IC Corporation

REVISED INSTRUCTIONS For VANDAL LOCK WARNING RECALL

**IC CORPORATION RECALL # 04305
NHTSA RECALL # 04V- 498**

Original Step # 3 for All States Except Ohio and Wisconsin and Step # 6 for Ohio and Wisconsin:

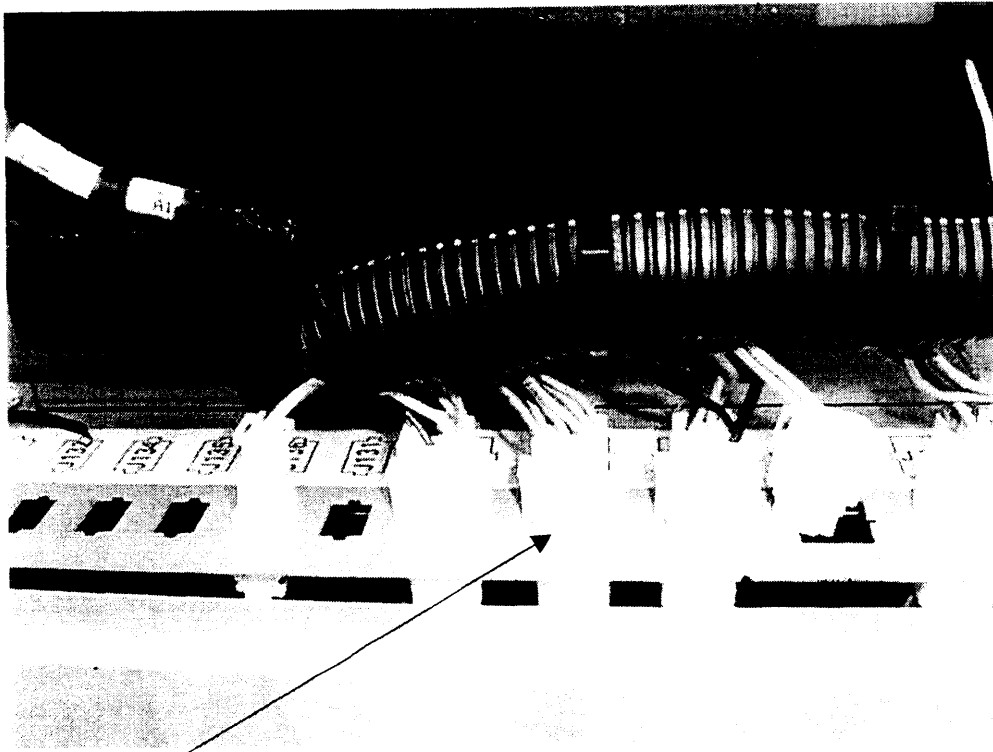
Find #58 pink wire located in the repair area identified in photo "B" and "C". The wire continues to route toward the rear of the bus and does not terminate in this location.

Find #58 pink wire that connects between the starter interrupt relay pin #86 at one end and to the lower left hand body connector J6. See backside for picture of J6 connector. (NOTE: There are four (4) number 58 wires connected to this relay so pay special attention and verify that you select the correct one). Performing a continuity check will confirm that the right wire is chosen. The relay with the pink number 58 wires may be located on either side of the body fuse block.
